ULNRC- 05224

**DOCKET NUMBER 50-483  
CALLAWAY PLANT  
UNION ELECTRIC COMPANY  
SUPPLEMENT/REVISION TO LICENSE AMENDMENT REQUEST OL-1258  
FOR REVISION OF TECHNICAL SPECIFICATION 3.7.3,  
"MAIN FEEDWATER ISOLATION VALVES (MFIVs)"**

MARKED-UP OF TECHNICAL SPECIFICATION PAGES

Figure 3.7.3-1 (Page 1 of 1)  
MFIV Stroke Time Limit vs Steam Generator Pressure  
3.7-8a

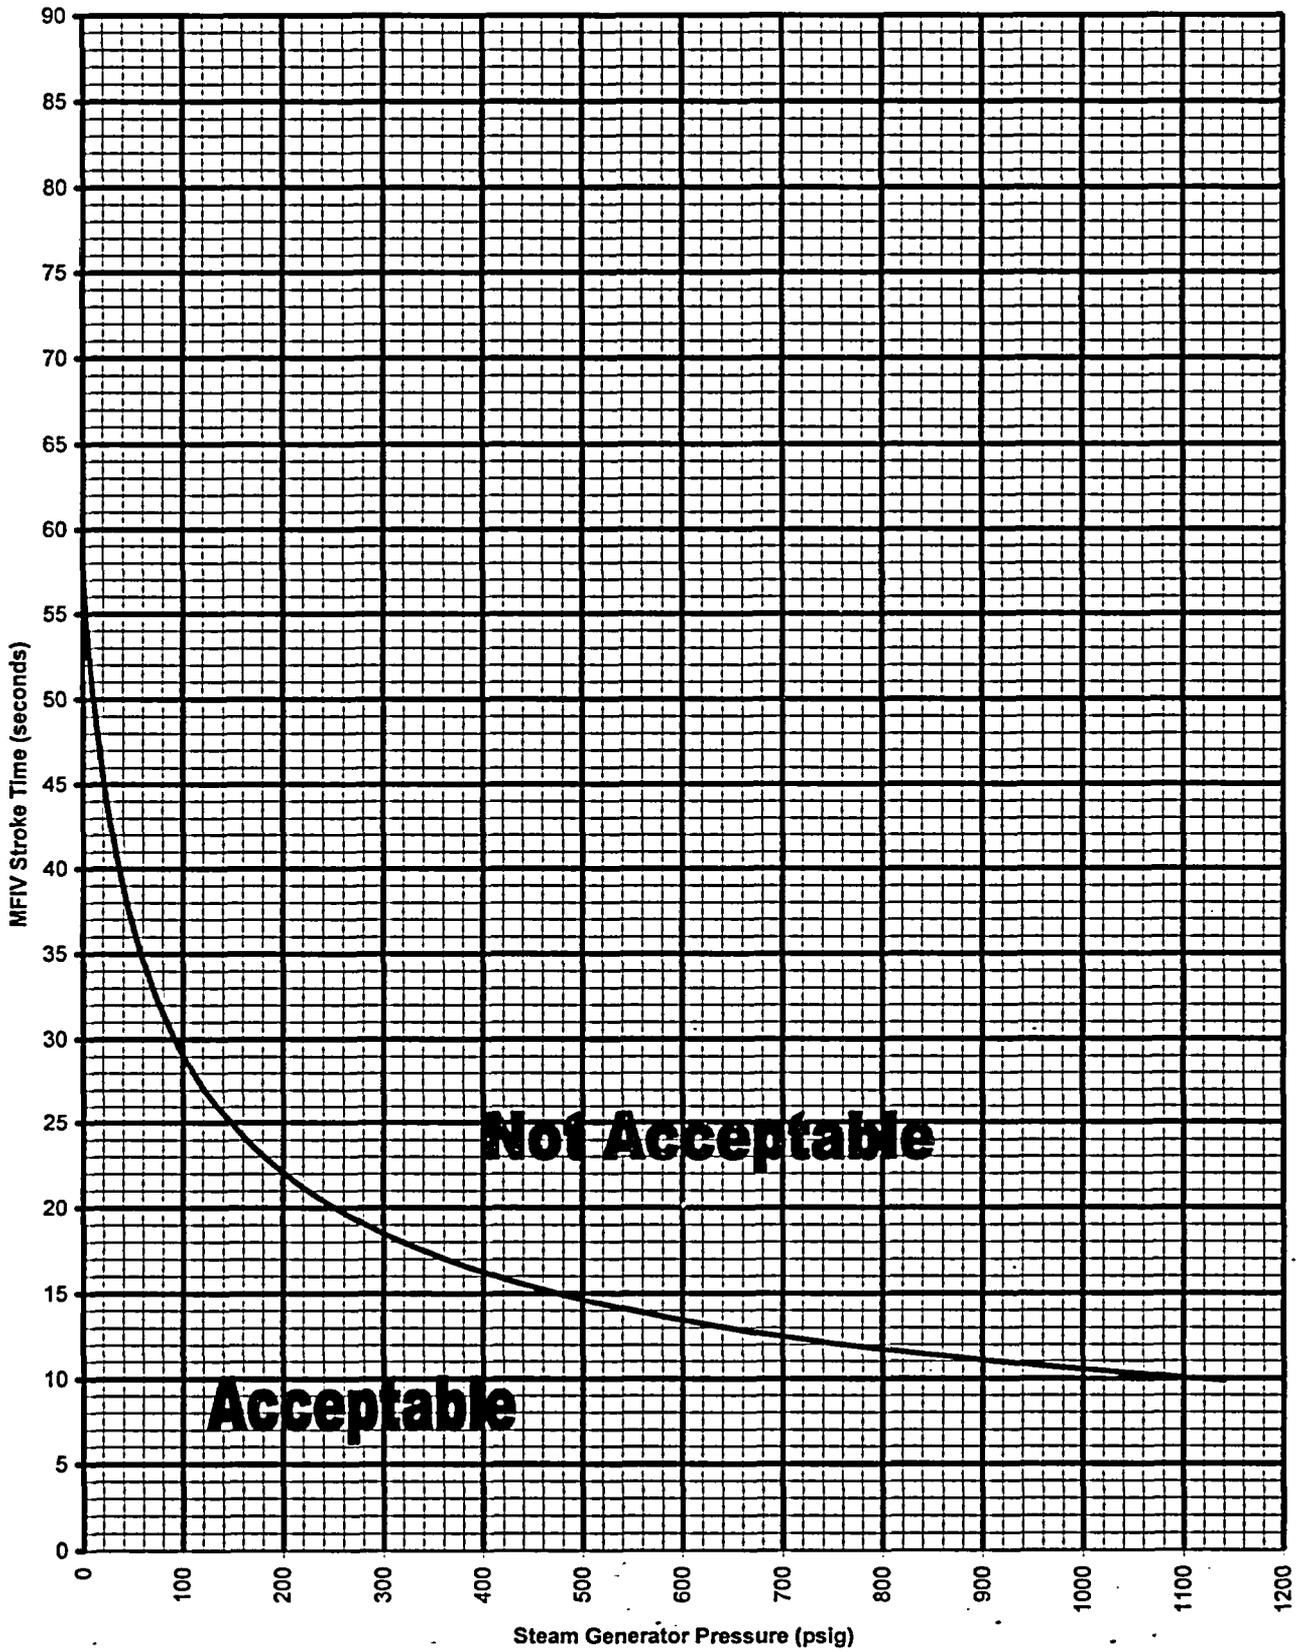
<b>SR 3.7.3.3</b> <b>Verify the closure time of each MFIV is within the limits of Figure 3.7.3-1.</b>	<b>In accordance with the Inservice Testing Program</b>
---	---

1. *The safety analysis limit curve for the MFIV closure time is presented in the figure provided in Attachment 6 to ULNRC-05206. This curve shows the MFIV safety analysis limits are 90 seconds at or below the P-11 permissive, and 15 seconds above the P-11 permissive. Therefore, it appears that this license amendment request is to change the safety analysis limit for the MFIV closure time from 15 seconds to 90 seconds at or below the P-11 permissive, but that the safety analysis limit above P-11 (i.e., the 15 seconds) is not being changed. The proposed Figure 3.7.3-1 (showing the acceptable MFIV closure times as a function of SG pressure) has a curve which is always less than the two MFIV safety analysis limits, so that demonstrating the MFIV closure time is within the acceptable range in Figure 3.7.3-1 would demonstrate that the measured MFIV closure time is also within the safety analysis limits and, therefore, the MFIV is operable with respect to its closure time. Discuss if the NRC staff's interpretation of the amendment request is correct and why, if the MFIV safety analysis limit above the P-11 permissive is not being changed, the effect of the 15-second closure time on accidents above the P-11 permissive is addressed in ULNRC-05206.*

7. *In the background on the MFIV actuators, on pages 2 and 3 of Attachment 1 to ULNRC-05206, there are the statements that the actuators use the pressure of the process fluid to close the MFIVs, an inherent feature of the actuators is that the valve closure time is a function of the system conditions (pressure and temperature), and the valves tend to close more slowly at lower SG pressure. Explain the relationship used to correlate the system conditions at the MFIVs to the pressure in the SGs so that the MFIV closure time in Figure 3.7.3-1 is presented as a function of the SG pressure.*

8. *Given the figure in Attachment 6 to ULNRC-05206 on the measured MFIV closure time as a function of SG pressure, explain the basis for the assumption of a 90-second maximum time for MFIV closure at or below the P-11 permissive. (Below the P-11 permissive SG pressure, the maximum MFIV stroke time is shown in proposed Figure 3.7.3-1, for zero SG pressure, to be less than 60 seconds.)*

11. *In the discussion on the implementation of MFIV testing required by SR 3.7.3.3 on page 11 of Attachment 1 to ULNRC-05206, it is stated that "it is AmerenUE's intent to perform stroke-time 'baseline' testing of the MFIVs at several pressure values over the test pressure range." Address this statement by describing what testing has been done on the MFIVs prior to this application and what testing will be done during the implementation of this proposed amendment including the test pressure range. Address the testing that would be done for "actual plant conditions (using only a single actuation train to stroke each MFIV)" and how the curve for the "calculated single train stroke time" in the MFIV closure time versus SG pressure figure, which is in Attachment 6 to ULNRC-05206, was determined. For the testing during implementation of the proposed amendment, discuss the assurance that Figure 3.7.3-1 will bound any testing of the MFIVs and what would be done if the testing using a single actuator train would show that Figure 3.7.3-1 is not conservative.*

13. *In the footnote on the bottom of page 3 of Attachment 1 to ULNRC-05206, there is the statement that the TS surveillance does not explicitly state that closure time testing of the MFIVs is done using one actuator train. However, in Attachment 4 to ULNRC-05206, there is the following statement in Insert 4 for page B 3.7.3-7 of the TS 3.7.3 Bases for SR 3.7.3.3: "This SR verifies that the closure time of each MFIV is within the limits of Figure 3.7.3-1 from each actuation train when tested pursuant to the Inservice Testing Program." Discuss if this sentence would require that the verification specified in SR 3.7.3.3 would be for each MFIV with only one actuator train working. Include in this discussion, the answers to the following questions:*

*Is the measured closure time for each MFIV with only one actuator train working compared to the closure time in proposed Figure 3.7.3-1, or is the MFIV tested with both actuators working and then corrected for the single failure of one actuator train? Is the proposed Figure 3.7.3-1 for only one actuator train, or for both trains, working to close an MFIV.*

The above interpretation is correct with respect to what is shown on proposed Figure 3.7.3-1, but it should be noted that it is not the intent of the license amendment request (LAR) to request changing the safety analysis limit for the MFIV closure time from 15 to 90 seconds. More precisely, the LAR was submitted for the purpose of changing the Technical Specification acceptance criteria for the MFIV closure time.

The vendor-calculated single-train performance curve was established using shop test data and validated with Callaway-specific single-actuation train field test data under high Mode 4 and Mode 3 normal operating pressure/normal operating temperature (NOP/NOT) conditions. To establish desired stroke time test margin, discussions with Westinghouse determined that a stroke time of 90 seconds below P-11 could be supported through re-evaluation and re-analyses. Based upon this information, the vendor-supplied single-train performance curve was adjusted upwards to provide test acceptance criteria that would be well within the analysis values, particularly the limit of 90 seconds with no steam generator steam pressure at the MFIV. This pressure-based performance curve was then correlated to steam generator steam pressure by conservatively reducing the pressure for each corresponding stroke time point on the curve by 19.1 psig [which is the difference in head elevation between RSG water level at 100% (narrow range) and the elevation of the MFIVs], thus establishing the curve provided as proposed Figure 3.7.3-1.

Consistent with the response to Question 7, an analysis stroke time limit of 90 seconds was selected for the range of pressure below the value corresponding to P-11 in order to fully bound expected stroke times in this range relative to the applicable accident analyses as re-evaluated for the RSGs. This provides margin between the limits/assumptions of the safety analyses and the test acceptance criteria developed for the MFIVs at low pressures.

The footnote and Bases insert are consistent in their description of how the MFIVs are to be tested. That is, each MFIV will be closed (when stroke-time tested pursuant to proposed SR 3.7.3.3) via only one of its two actuation trains at a time. Proposed TS Figure 3.7.3-1, which is the same plot indicated by the "Sample TS Curve" on the figure provided as Attachment 6 to ULNRC-05206, assumes and is based on each MFIV being closed via a single actuation train. Attachment 6 includes additional plots such as the Calculated Dual Train Stroke Time and the Calculated Single Train Stroke Time to provide an indication of how different the test results could be when stroking the valves closed using both actuation trains versus a single train. Nevertheless, testing pursuant to SR 3.7.3.3 will require each MFIV to be closed via only a single actuation train, consistent with single-failure/redundancy concepts incorporated into the MFIV design (i.e., that either actuation train can effect closure of the MFIV(s) in the event of a failure or unavailability of the other train). As noted in the LAR, the curve of proposed Figure 3.7.3-1, which constitutes the acceptance criteria for this SR, will be validated by testing (using only a single actuation train at a time for each MFIV) as part of the implementation of the requested license amendment.
